PROPERTY LOCATION: AUGUSTA Meadows Rd. Street, Road Subdivision Name Lot No.

APPLICATION FOR SUBSURFACE WASTEWATER DISPOSAL PERMIT

Subject: New System Variance to the Maine Subsurface Wastewater Disposal Rules, McGlaughlin property, Meadows Road, Augusta

New System Variance Request

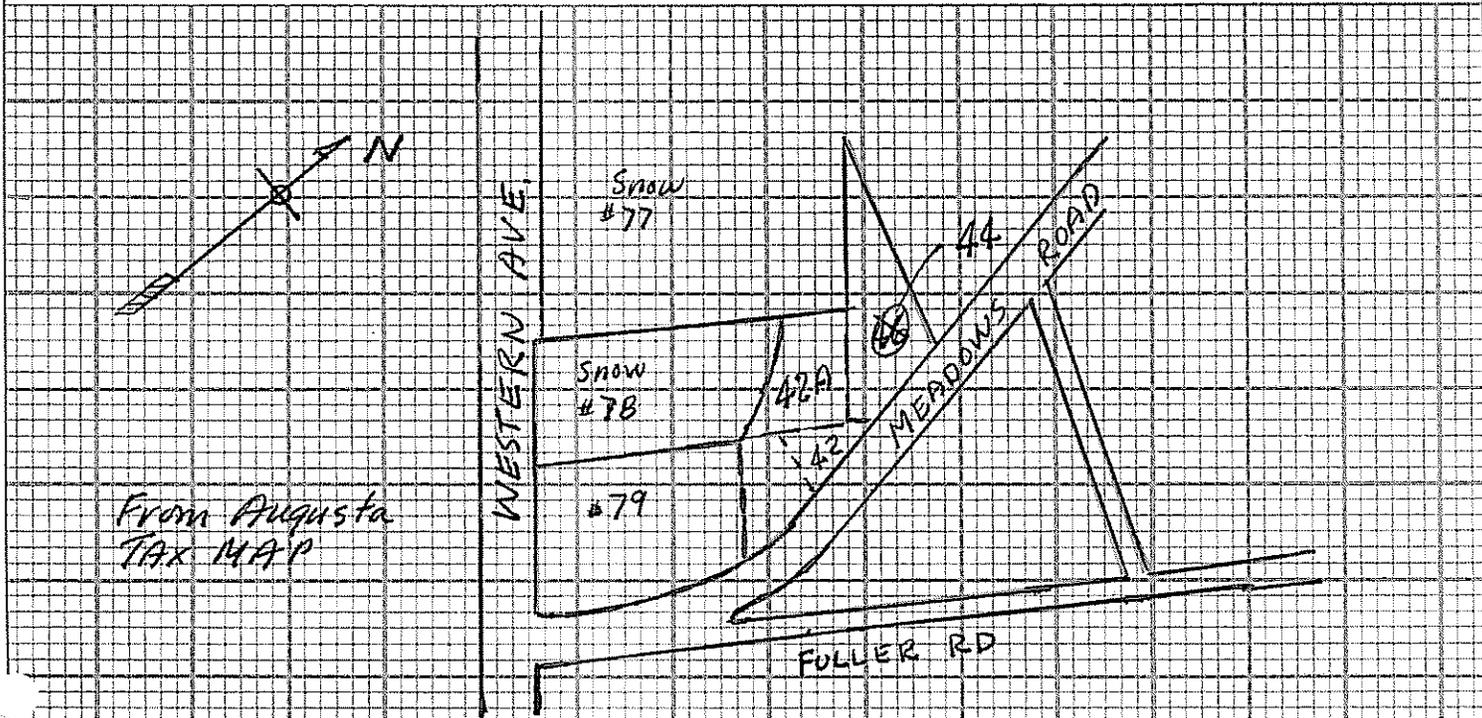
1. Setback distance from treatment tank to building on a slab foundation from 15 feet to 5 feet.

An area approximately 1 foot in depth by 20 feet wide and 80 feet long will be excavated in the fill and replaced by good clean bank-run gravel. The chambers would then be placed at the upper end of this gravel pad and the system then backfilled with existing fill material.

The 5' Variance to Septic Tank is requested to eliminate excessive slope excavation. 5' is allowed for existing bldgs. and replacement systems. The 4 chambers, the 1' gravel bed and the 3'± of granular fill should be more than adequate for the 50 gpd.

In consideration of the HHE-200 Form dated April 1, 1981, along with the recommendations and justifications noted on the HHE-215 Form, this office hereby grants the responsible local plumbing inspector the authority to waive certain provisions of the Subsurface Wastewater Disposal Rules, for the following new disposal system under the authority of Section 16.A of the Rules.

The installation of a 1000 gallon septic tank followed by a cluster of 4 type 'B' chamber units.

This office points out that the rules require that the Site Evaluator, Mr. Wiesendanger, be retained to stake out the system and elevations at the time of construction of the system.
